Starter Cable May Contact Power Steering Hose

RECALL

Models Affected: 2004 through 2006 Model Year "Vision"

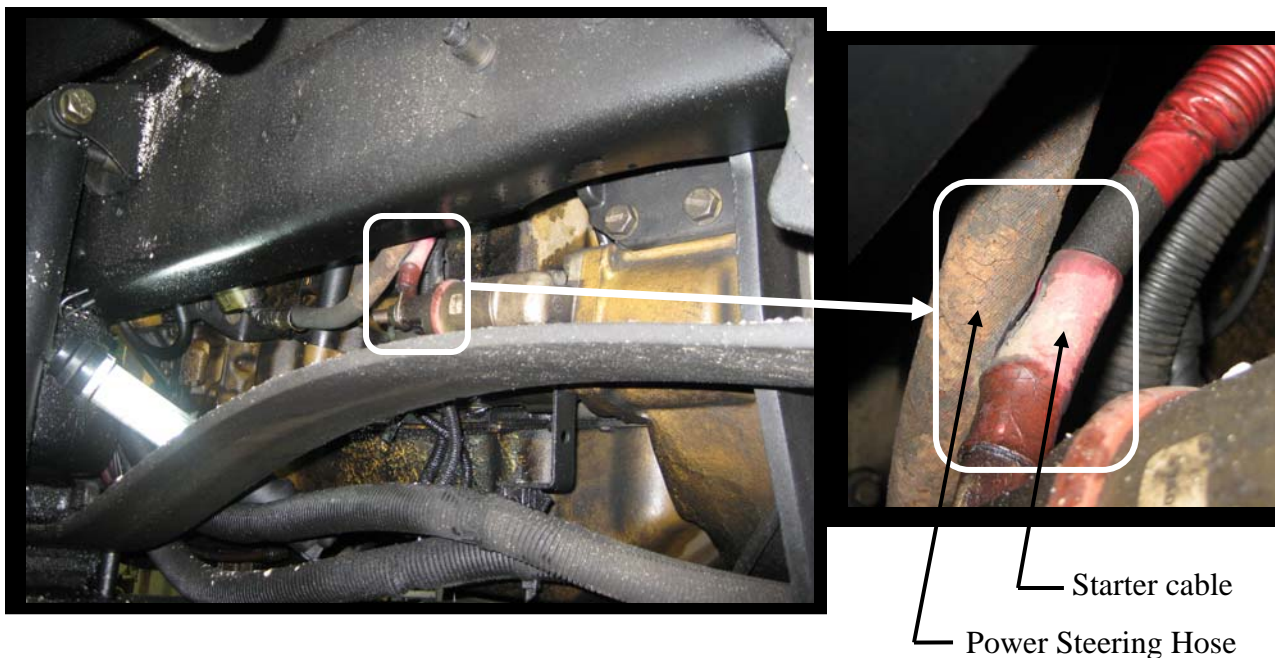
The starter cable may contact and potentially chafe against the steel braided power steering hose thereby creating a direct short which could result in a fire.

1. Park the bus on a level surface, apply parking brake, and remove ignition key and chock wheels.
2. Disconnect Batteries: Note when disconnecting the batteries, remove the Negative cable first.
3. On lower left side (driver's) of engine; inspect the positive starter cable and power steering hose for possible contact as shown below.

Inspect for proper clearance between the starter cable and the power steering hose. If insufficient clearance is found, install a clamp to prevent further contact. Any damaged power steering hoses or starter cables must be replaced.

Install dual swivel saddle mount and cable ties.

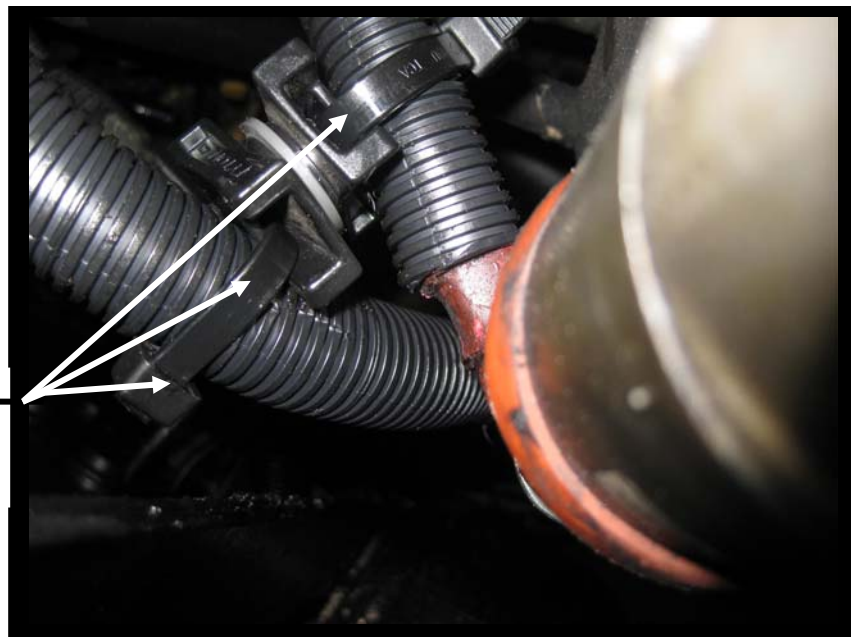
- 4. If the starter cable has contacted the power steering hose, separate and inspect both for any possible damage. If either has been damaged, contact Blue Bird Recall Administrator for a replacement.
- 5. If there is no contact and a minimum of one (1) inch clearance between the starter cable and power steering hose, no further action is required.
- 6. If there less than one (1) inch clearance, install a dual swivel saddle mount and two cables ties between the power steering hose and starter cable and secure with two cable ties.
